**Response to Comments on Draft National Pollutant Discharge Elimination System (NPDES) Permit No. MA0003905 - General Electric Aviation (GE)**

In accordance with the provisions of 40 C.F.R. §124.17, this document presents EPA’s and the Massachusetts Department of Environmental Protection’s (MassDEP)<sup>1</sup> responses to public comments received on the Draft NPDES Permit (MA0003905) for General Electric Aviation’s facility in Lynn, Massachusetts (GE). This response to comments (RTC) document not only provides responses public comments, but it also explains and supports the EPA and MassDEP determinations that underlie the Final Permit.

Figure 10.3.1 Comparison of GE’s Case 5 and Case 2 modeling results including power generation, river flow, and intake flow for the period from July 1 through September 30.

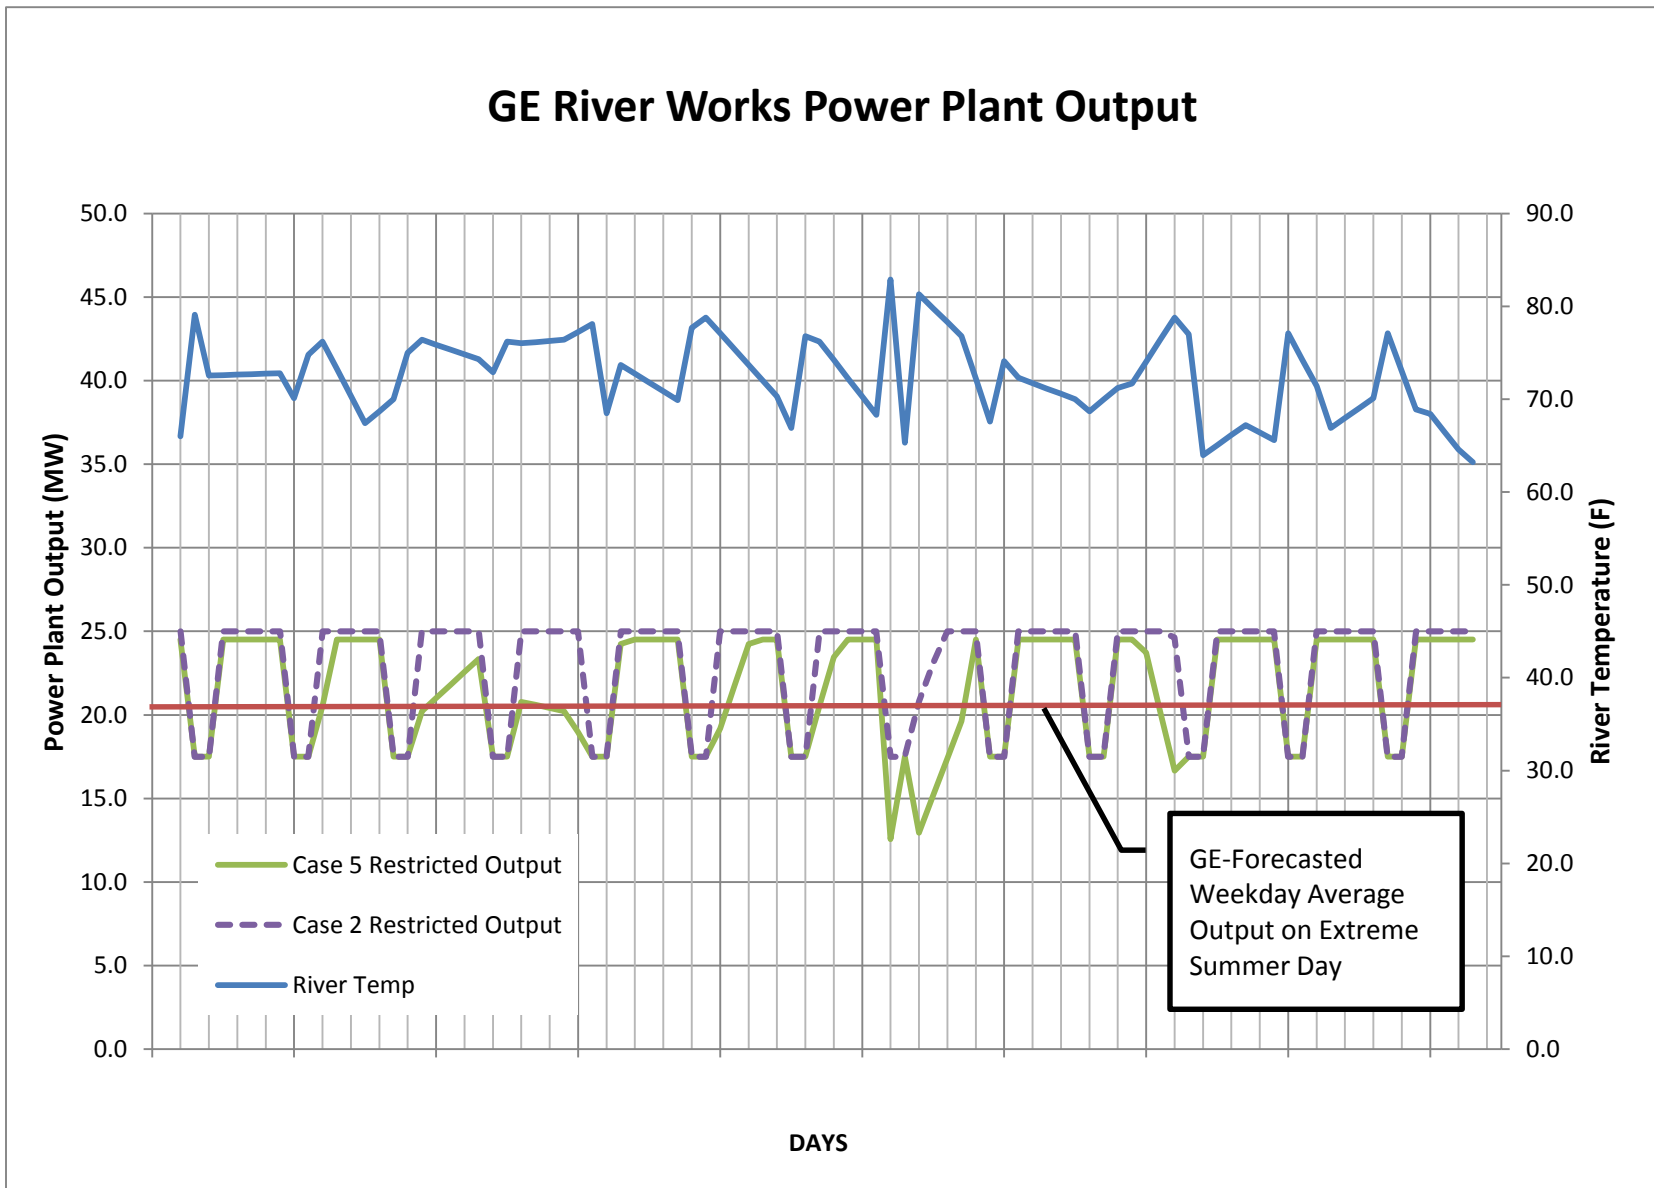
EPA compared power output between “Case 5” and “Case 2” for the July 1 through September 30 time period, when biological impacts on the aquatic community from thermal discharge would be most likely to occur (Figure 10.3.1). Under Case 5, weekday power output is expected to be restricted further than GE’s proposed 30% reduction on approximately 25 days per year, and the average weekday power output is anticipated to be about 23 MW (34% reduction). This can be compared to an average weekday power output of 25 MW (a 29% reduction) under Case 2. In both cases, the weekend power output generally meets the required level (17.5 MW). For Case 5, the projected minimum output is about 13 MW (a 63% reduction), which occurs when the intake temperature is at its peak (greater than 81°F). This condition is expected to occur rarely; based on the recorded intake temperature between 2001 and 2004, the projected intake temperature would be anticipated to exceed 80°F on approximately two days per year. Based on analysis of GE’s operational model, the anticipated average daily output from the Power Plant under Case 5 (maximum temperature limit of 90°F) during the summer would not be expected to be substantially less than the expected average daily output during the summer for GE’s proposed operating conditions under Case 2, provided that GE is authorized to intake a higher volume of water equivalent to the maximum daily flow limit of 35.6 MGD with no reduction in average monthly flow during this period.

According to GE's model, the average daily output from the Power Plant on an extreme summer day (based on a Forecast from August 6, 2009) is 20.2 MW with a once-through cooling flow of 35.6 MGD. Under Case 5, the Power Plant output is expected to be less than 20.2 MW on only approximately 7 days per year. Operational profiles from GE indicate that the average hourly steam use during the summer (July to September) for heating, manufacturing, and test steam is less than 40,000 million pounds per hour (Mlb/hr) and generally less than 20,000 Mlb/hr (See Figure 10.3.1). This is consistent with GE's characterization of limited operations during the hottest months. During July through September, GE's plant operation profiles indicate that only the 200 psig steam is produced. From this assessment, EPA concludes that applying the more stringent temperature limit of 90°F during summer could be feasible if the facility were authorized to intake an average monthly flow limit of 35.6 MGD.

Nevertheless, EPA has concluded that, based on available information, a year-round discharge temperature of 95°F would reasonably assure protection and propagation of the BIP because the primary thermal impacts of concern appear to be limited in both size and duration and organisms would likely be able to avoid conditions that could result in acute toxicity. At a higher discharge temperature, the average monthly flow can be reduced by 20% year-round, including summer months when early life stages may be present, which will reduce mortality due to entrainment and impingement and further protect the BIP. Therefore, the Final Permit applies a year-round maximum discharge temperature limit of 95°F and an average monthly flow limit of 28.5 MGD at Outfall 018. In addition, according to GE, the steam requirements of the Test Cell are limited in summer, which should reduce the potential thermal impacts on those days when the ambient temperatures are likely to be highest.

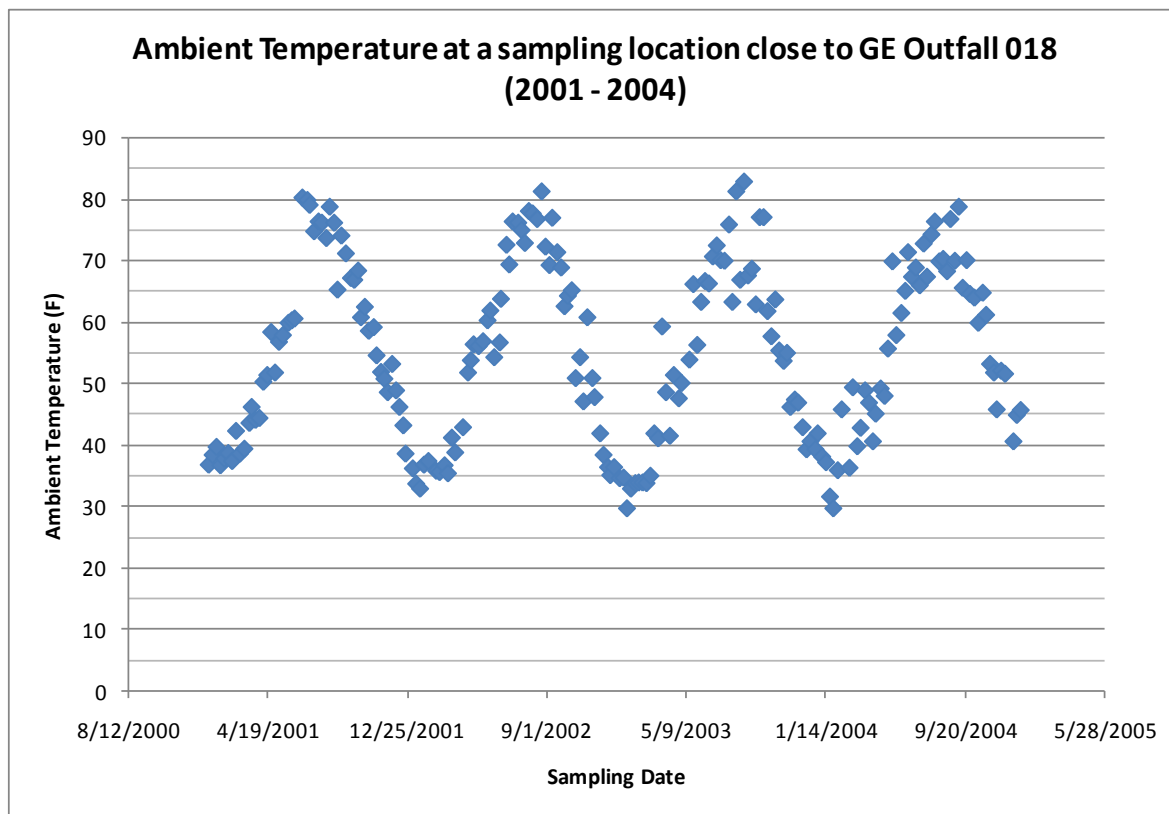
As demonstrated by the plan-view and cross-sectional figures of the modeled thermal plume in Technical Exhibit 18 to these comments, the Power Plant thermal plume projects away from the shoreline out into the deeper main channel of the river (Technical Exhibit 18, Figure 2.7). The lateral distance of the plume from Outfall 018 (following its trajectory as shown in Technical

Exhibit 18, Figure 2.7) and its depth below the surface during low-water slack tide (Technical Exhibit 18, Figure 2-3) show that (1) the plume does not extend across the river to the shallow-water and saltmarsh habitats near the southern shore of the river, and (2) a substantial zone of the river (in terms of both width and depth) is unaffected by the 2°F isotherm. Thus, even at low-water slack tide, a substantial zone of passage remains in the Saugus River in the vicinity of Outfall 018 for juvenile fish to avoid rapid exposure to and swim away from the relatively gradual change in temperature associated with the thermal plume. Moreover, these conditions represent the maximum extent of the plume under low-water slack tide. That condition persists for less than 30 minutes, further limiting the exposure of young fish to elevated temperatures.

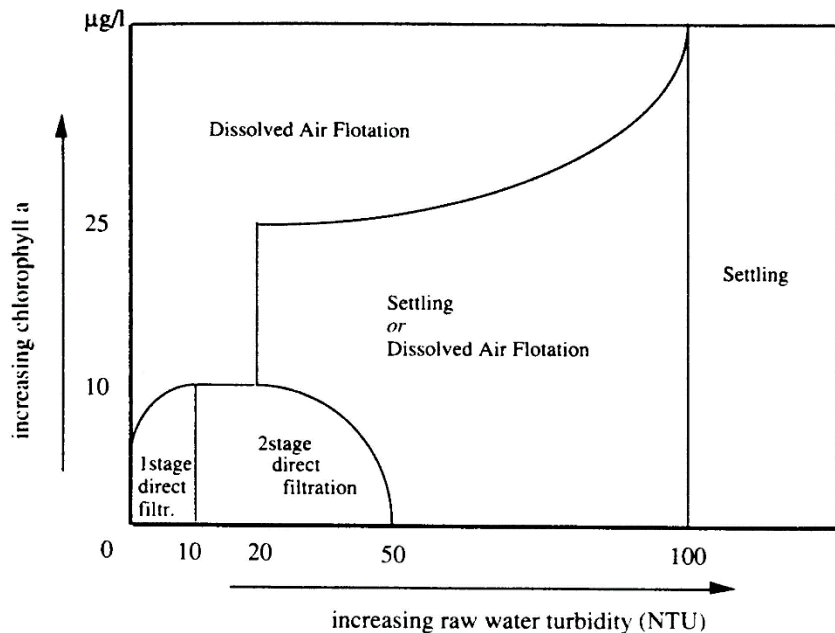
EPA assumes that “pollutant discharges would be reduced the most by operating the CDTS in the mode utilizing both DAF and GAC treatment.” Fact Sheet p. 8. However, this assumption is not correct. To fully understand this issue, it is critical to first address the original design philosophy of the CDTS, and to compare this design philosophy to GE’s actual operating experience over the last ten years.

The design and installation of the CDTS was an element of GE’s comprehensive sheen reduction program. During the design process, GE’s understanding of the sheen issue was evolving. As a result, the CDTS design philosophy accommodated a wide range of influent characteristics and provided the operating flexibility necessary to achieve the discharge performance standards. In this regard, a key unknown was the amount of free product or floating oil and grease that would be present in the wastewater pumped from the respective drainage system vaults to the CDTS. To address this unknown, dissolved air flotation (DAF) technology was selected as an element of the treatment system to provide the capability for the removal of free product and floating oil and grease should these pollutants exist in sufficient quantity.
